No:	Revisions:	Date:
1	FRANKLIN COUNTY COMMENTS	02/27/09

DESIGN BY:	BKS/MEP
DRAWN BY:	BKS
REVIEWED BY:	MEP
PROECT NUMBER:	FCPP1004
PROJECT:	ROANOKE/FRANKLIN COUNTY WATERLINE EXTENSION PHASE II U.S. ROUTE 220 FRANKLIN COUNTY, VA
TITLE:	Plan and Profile STA – 295+00.00 to 310+00.00
DRAWING NAME:	STA – 295+00.00 to 310+00.00.dwg
SCALE:	H: 1" = 50' V: 1" = 10'
DATE:	01/14/09
DRAWING NUMBER:	C20
SHEET NUMBER:	22 of 28

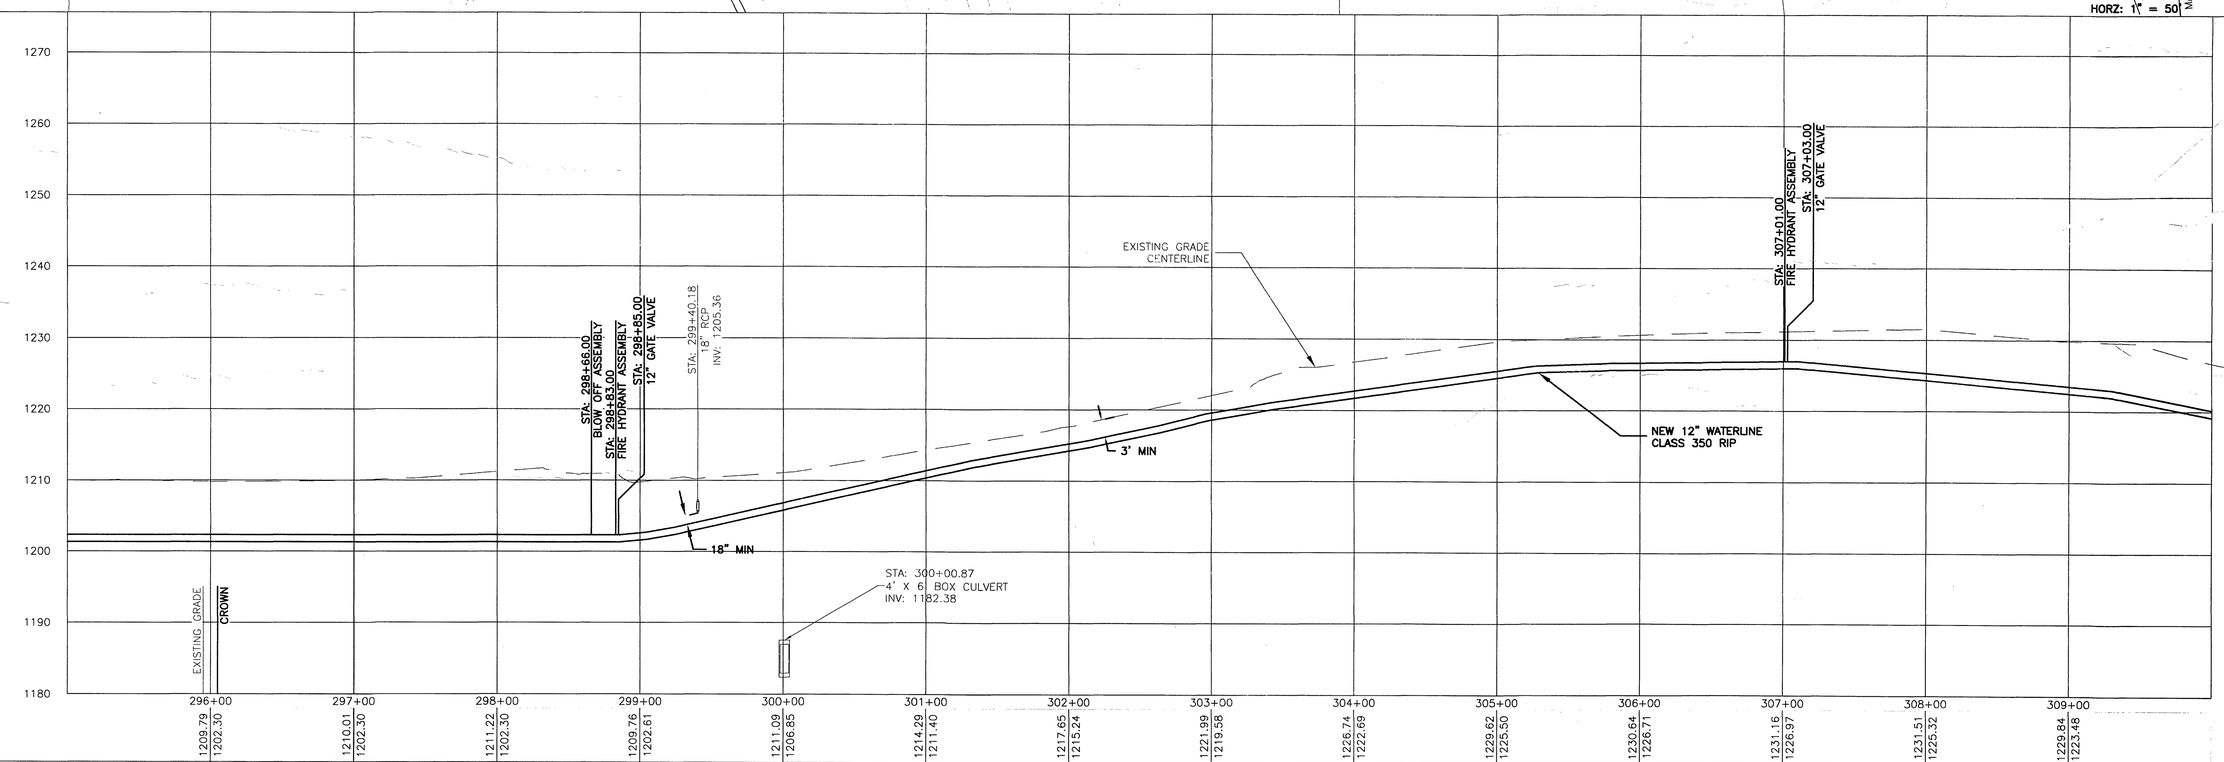
STA: ~~298+66.00~~ Do not install
NEW BLOW OFF ASSEMBLY
Project To Abandon
727'
Elwood Wray Rd
TEST
GV 13

STA: 298+83.00
NEW FIRE HYDRANT ASSEMBLY
60192
moved
STA: 298+85.00
NEW 12" GATE VALVE
#19

It is 43' From
G.V 19 to F.H 60192

moved in front of guardrail

It is 895' From
G.V 19 to G.V 20 and
it is 943' From G.V 20
To F.H. 60192

STA: ~~307+01.00~~ 68
NEW FIRE HYDRANT ASSEMBLY
moved
60193

STA: 307+~~03.00~~ 70
NEW 12" GATE VALVE
moved
#20
885'
